IN THE DRAWINGS

REMARKS

ROC920030193US1

FIG. 2

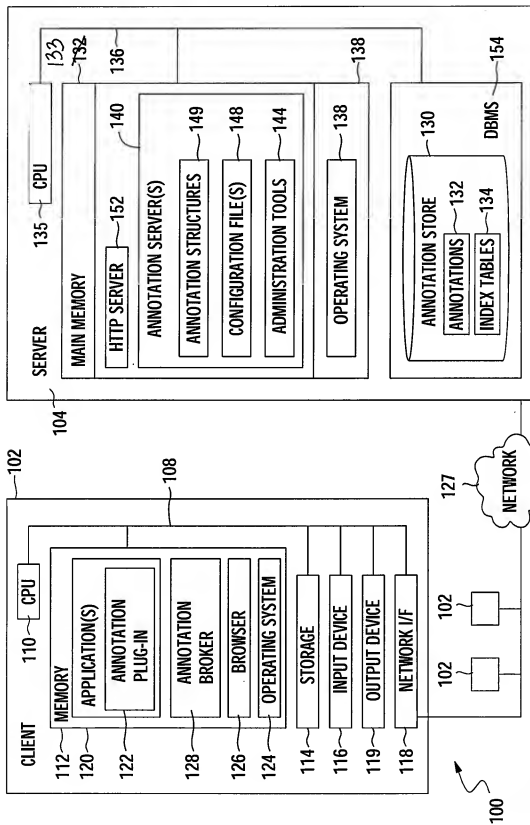
The attached sheets of drawings include changes to figures 2, 5A and 5B. Amended figure 2 is labeled identify main memory 133. Amended figure 5A is labeled to identify GUI panel 530. Amended figure 5B has been labeled to identify GUI panel 532.

Amended figure 2 is labeled identify main memory 133. Amended figure 5A is labeled to identify GUI panel 530. Amended figure 5B has been labeled to identify GUI panel 532.
